Project Name: Olivia

Street Address: 11 Sandra Lane
Pearl River, NY 10965

Project Description: (If additional space required, please attach a narrative summary.)
Single Story Addition

REFERRAL TO THE ZONING BOARD OF APPEALS

PROPOSED ADDITION

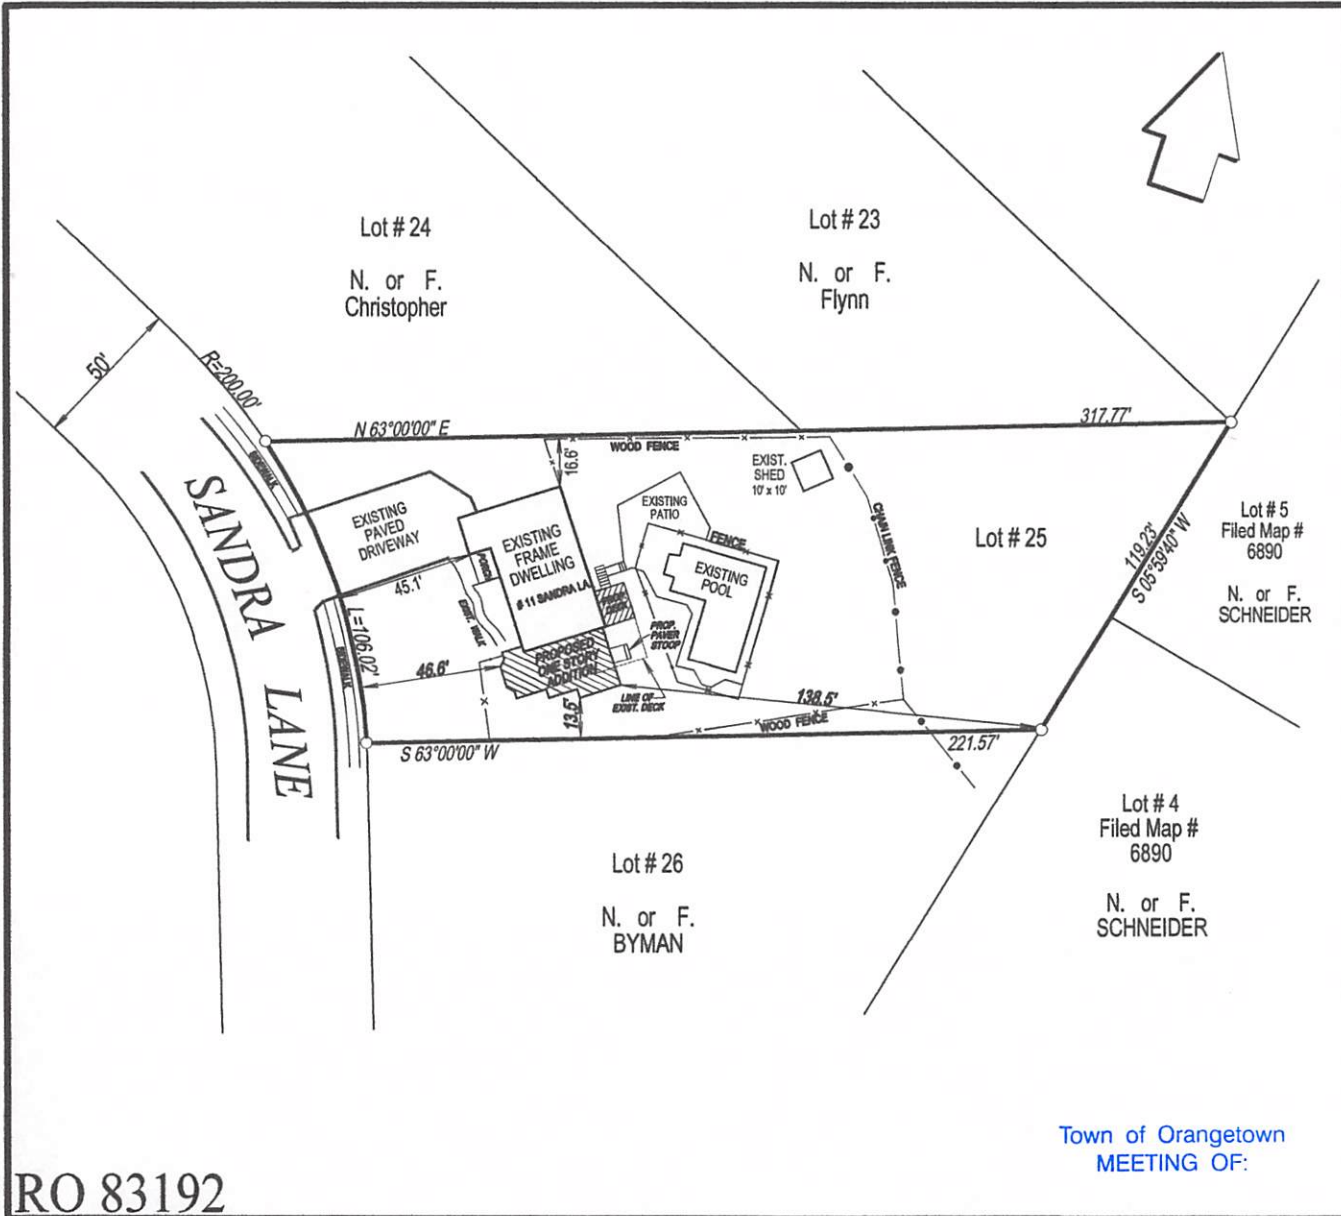
Chapter 43, Section 3.12 R-15 District, Column 9 Min Side Yd 20' w/ 13.5' proposed, Column 10 Min Total Side Yd 50' w/ 30.1' proposed,
Section 4.52 No significant exterior change with addition being added, 4.54 Shall be only 1 front entrance w/ 2 proposed, 4.58 Owner must have resided in dwelling for min 15 yrs w/ 3 yrs proposed, Use Table 3.11 for R-80 Column 2, #7, max sf 600 sf w/ 628 sf proposed

6 Variances required

Side Yd, Total Side Yd, Significant exterior change, second front entry
over 600 sf, Current owner less than 15yrs
